# Bulk Recovery Solutions

## 16 Kerr Road, Ingleburn

State Significant Development No 8593

Response to Submissions

Figure 1 – Hazardous Soils Process Flow Diagram

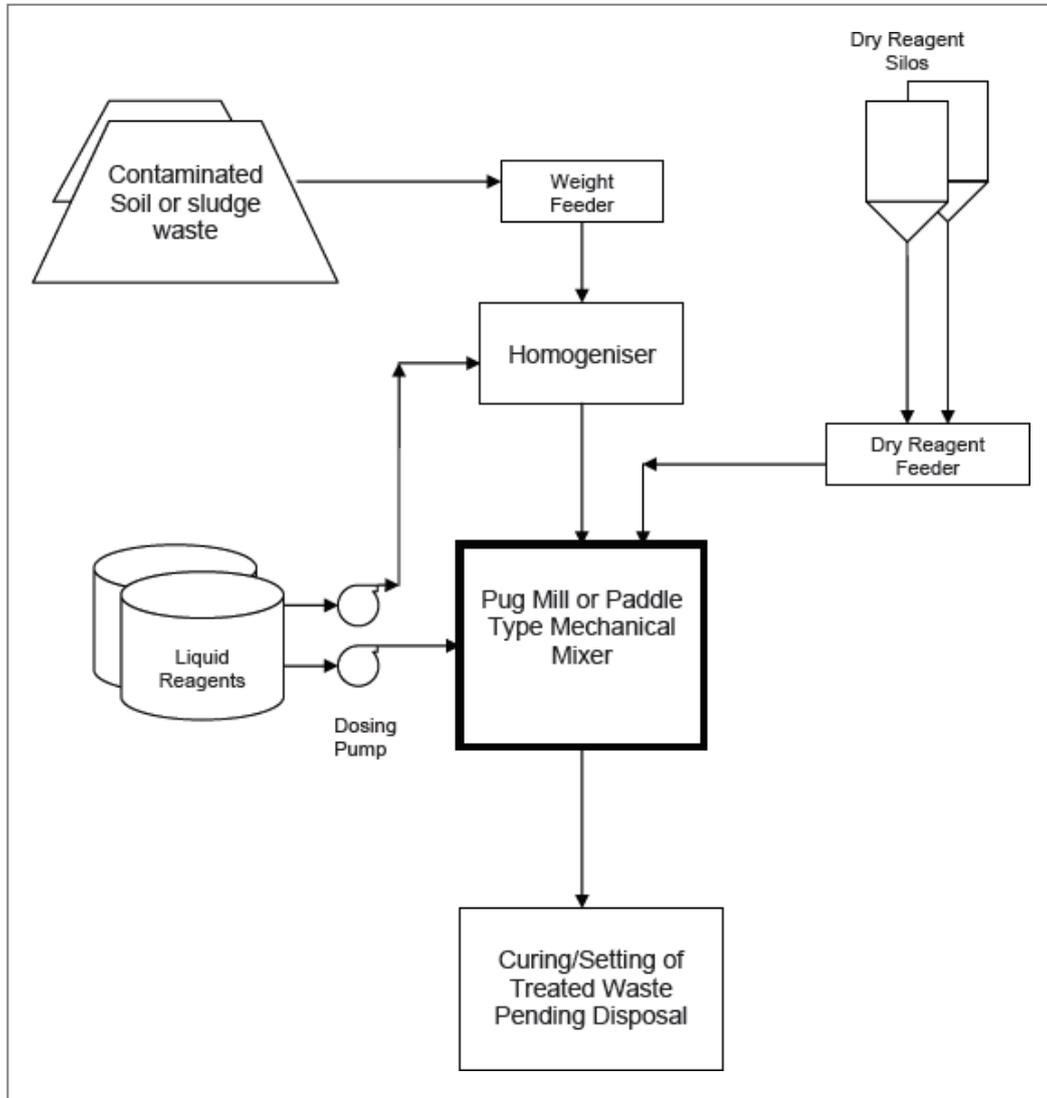
*Provide a detailed description of the treatment process to be used to treat the hazardous soils*

*Processing of the hazardous soils will involve the soil being fed into a homogeniser where liquid reagents are added manually. The material is then mixed by the proposed pug mill where further liquid and new dry reagents can be fed manually and mixed. Once appropriately mixed, the soil is left to settle/cure. The waste will be processed for a minimum 24 hours however, further treatment will continue until certified to be appropriate for disposal. The process is designed in accordance with the NSW EPA Immobilisation Technical Note 1 with an immobilisation approval for the component to be received from NSW EPA certifying the component is fit for purpose.*

*Further clarification of the hazardous waste process is provided at Section 4.6 of the updated EIS. Figure 1 provides a diagram of the proposed treatment process for hazardous soils.*

**Figure 15-1: Locations, Names, Dimensions and Capacities of Waste Storage Facilities**

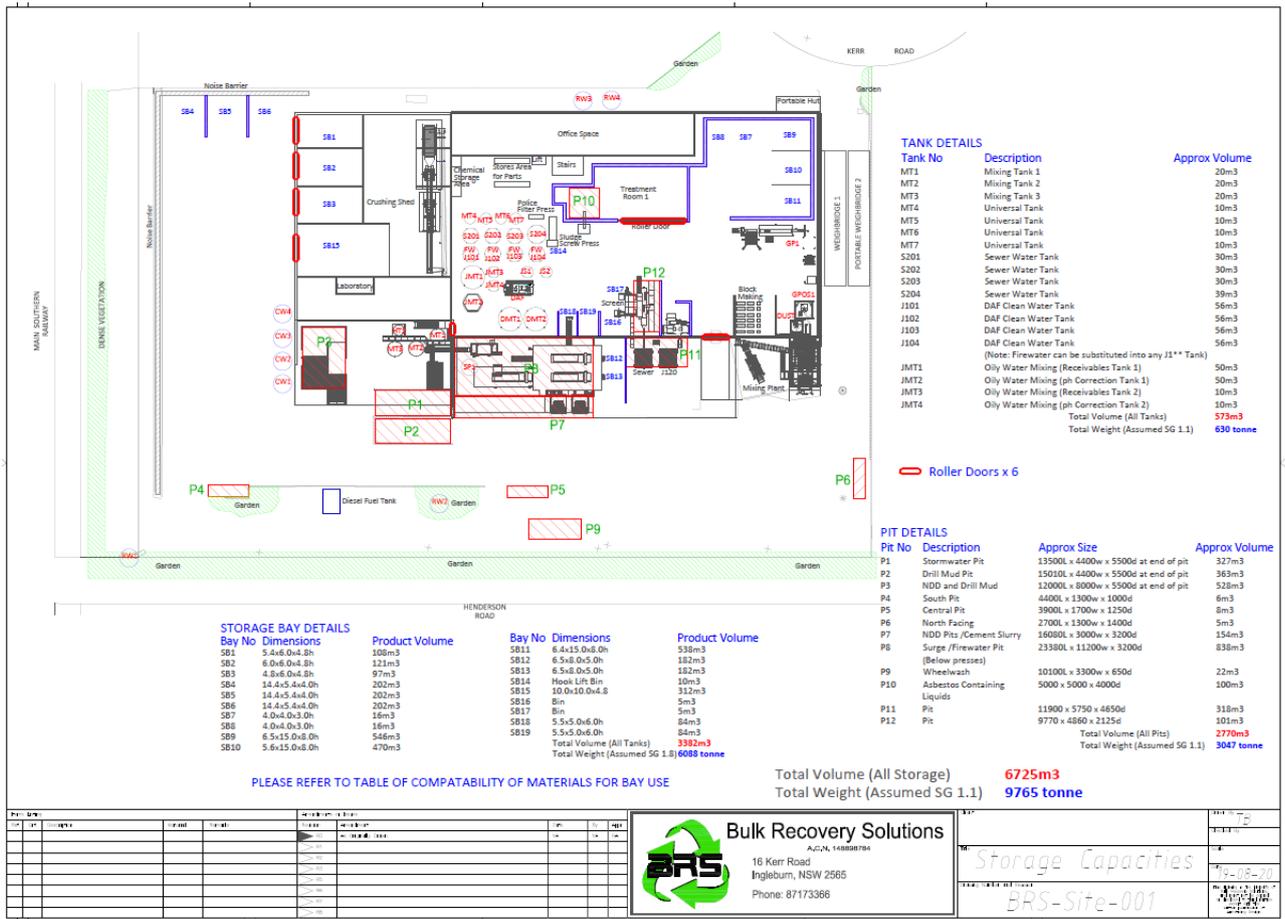
*We note that, in the RRtS, the applicant has reduced the amount of waste proposed to be stored at the site at any one time from the initially proposed figure of 15,000 tonnes to 7,129 tonnes. The applicant has provided some detail around the densities of both solid and liquid wastes used in the calculation of this amount.*

**The updated list of storage facilities and compatible waste storage bays include the proposed locations for all waste types and streams. Refer to Appendix H for names, locations, dimensions, capacities and compatibilities of all storage facilities. Tables 15-1 and 15-2 below include the requested information. Figure 15-1 provides additional details as well.**

However, the requested storage capacity at any one time is 8,000 tonnes which is very conservative amount to ensure that there is a flexibility in the management of waste storage on site. Refer to the Tables 15-1 and 15-2 as well as Figure 15-1 for comprehensive details of all storage facilities within the boundaries of the site.

**Figure 15-2: 2D Site Plan showing Site Structures and Features**

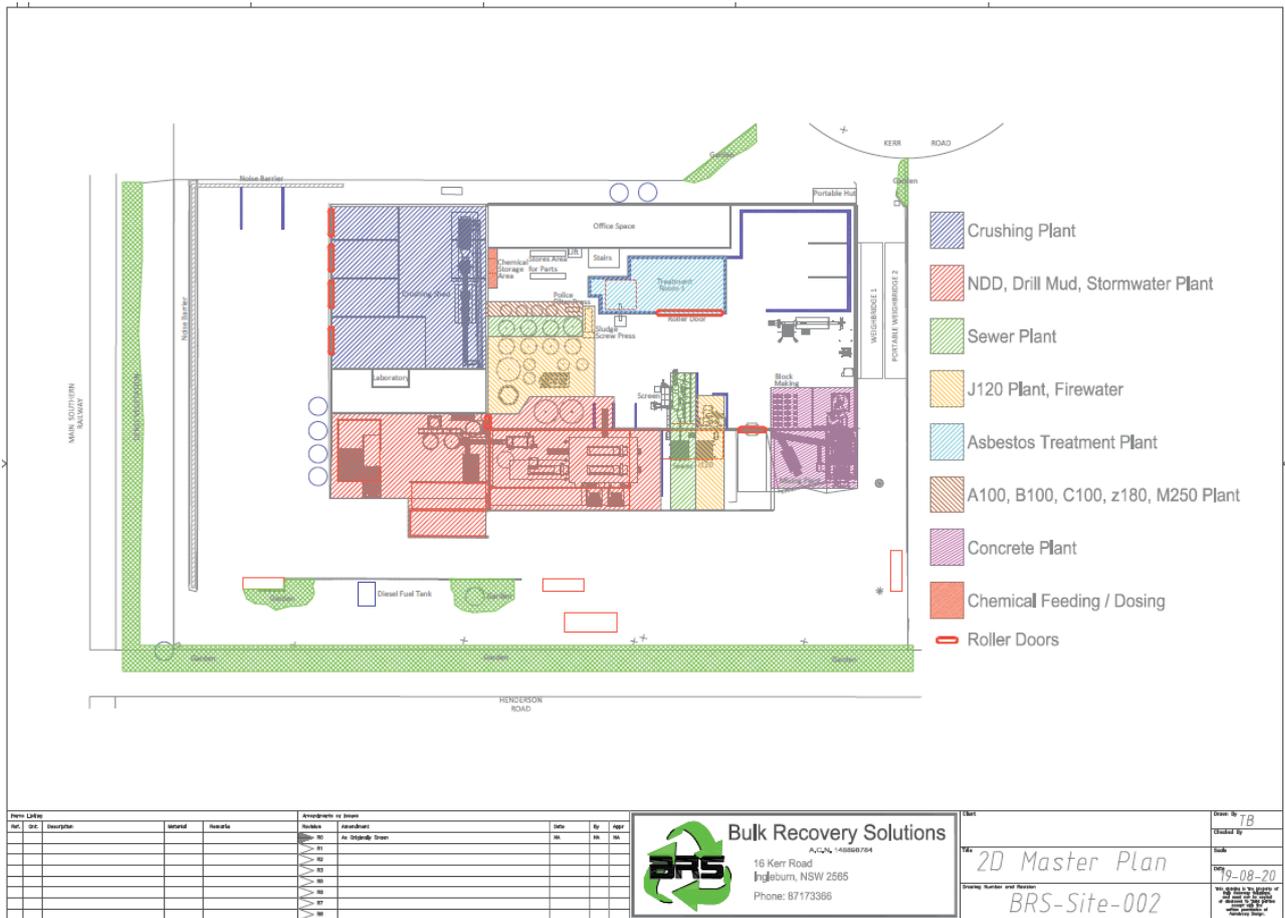
- c. all operations/activities*
  - d. the drainage bund surrounding the new solid waste receivals area/C&D tip and spread area*
  - e. the items in the process flow diagram in the RTS (Figure 3), being the homogeniser, weight feeder liquid reagents, dry regent feeder, dry regent silos and the location of the curing settling of treated waste pending disposal*

These were labelled in the previously submitted documents. Nevertheless, they are now highlighted further on the updated site plans. Refer to Appendix C for detailed 2D and 3D site plans which include details of the site features including the above requested items. Figures 15-2 and 15-3 provide details of such plans. However, Appendix C includes more detailed 2D and 3 D plans.
